PERRY NUCLEAR POWER PLANT

Perry Nuclear Power Plant
Docket Nos. 50-440; 50-441
Submittal of Changes to
Emergency Public Information
Organization Implementing
Instruction Manual

CONTROLLED DOCUMENT TRANSMITTAL

NON-INTENT INSTRUCTION TEMPORARY CHANGE

CEI WORK AREA LAYOUT
JOINT PUBLIC INFORMATION CENTER
CEI WORK AREA LAYOUT
 PERFORMING ARTS CENTER / ROOM D 2117

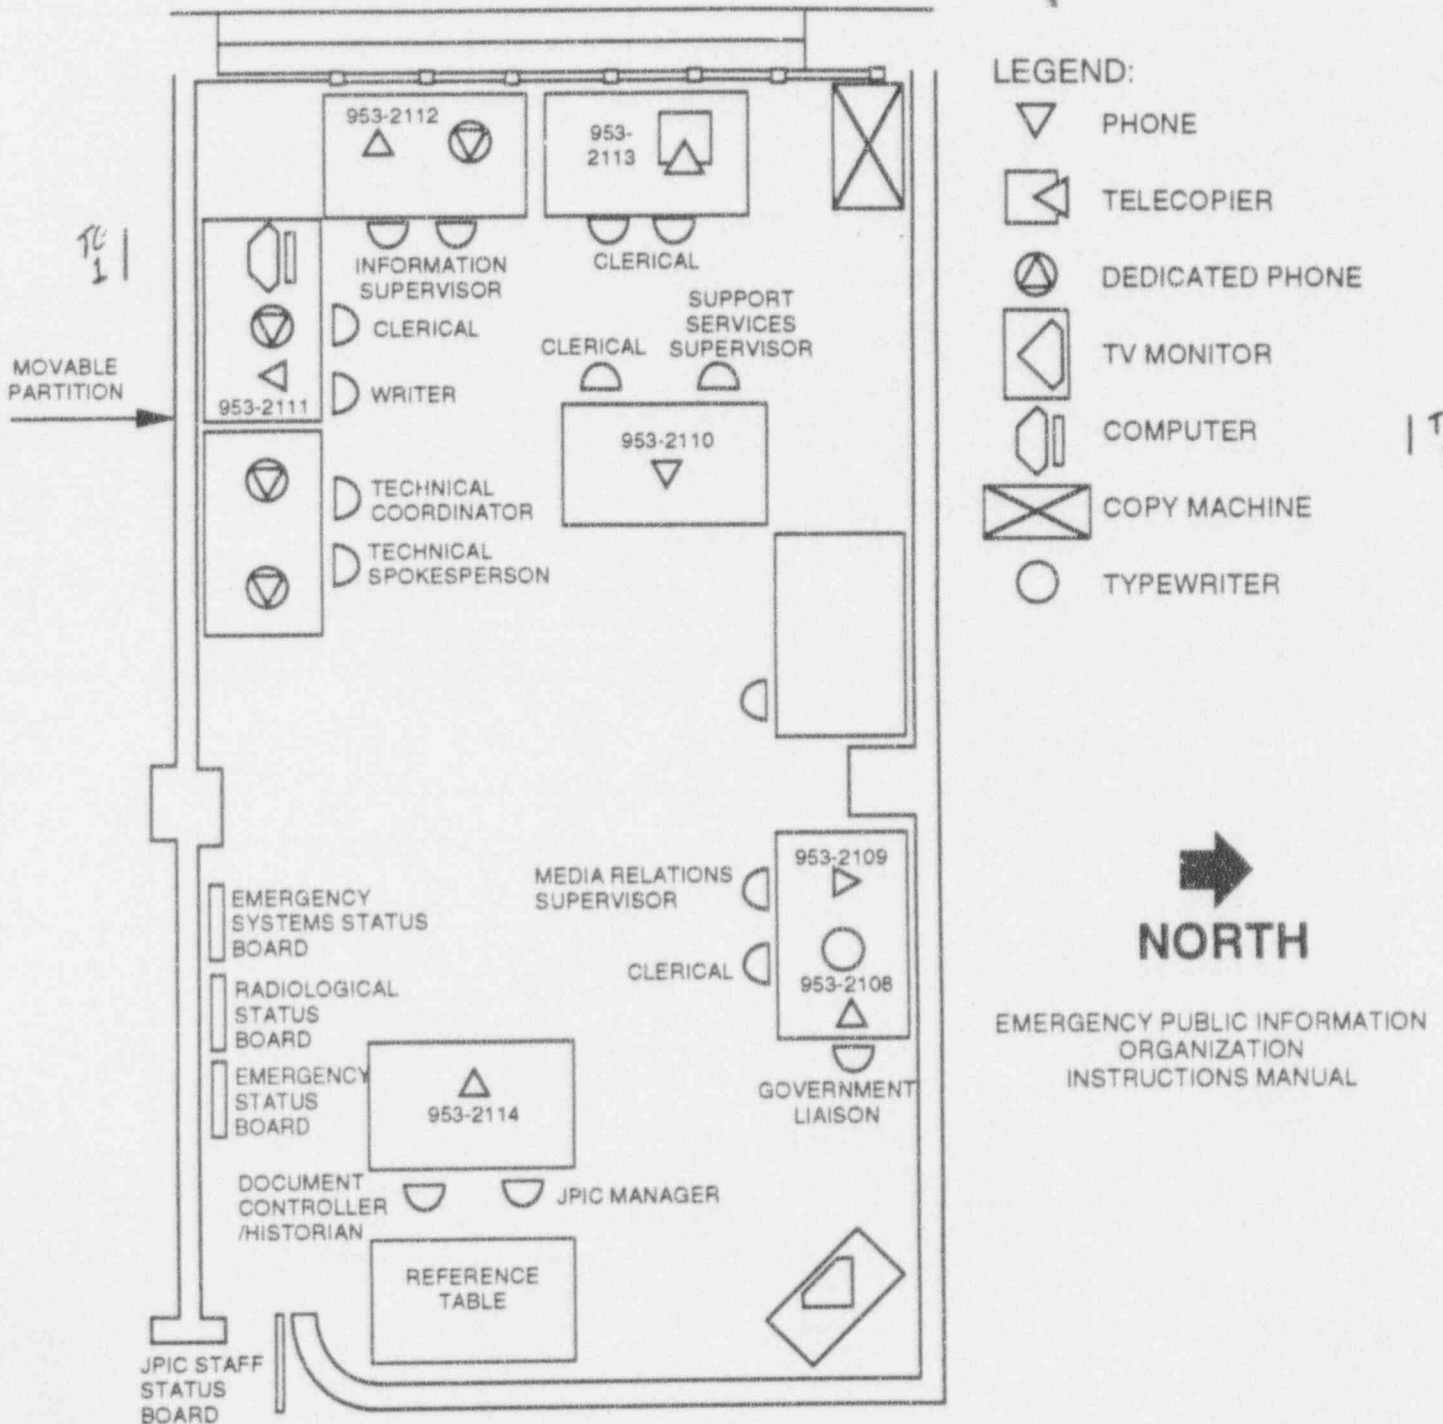
INSTRUCTION NO. <u>Appendix I Part A</u>	REV. <u>0</u>	INSTRUCTION TITLE <u>SOP for ACTIVATIONS OF IPIC FOR RESPONDING LOC NON-SECURITY</u>
CANCELS TCN(S): <u>N/A</u>		<u>PERSONNEL</u>
LIST EACH ATTACHED PAGE: <u>15</u>		ADMIN. USE ONLY PNPP  No. 7 2 3
PREPARER <u>Denny K Harrison</u>	DATE <u>13-25-93</u>	
REASON <u>o Replace floor plan for CEI work area - Computer replaces memory typewriter</u>
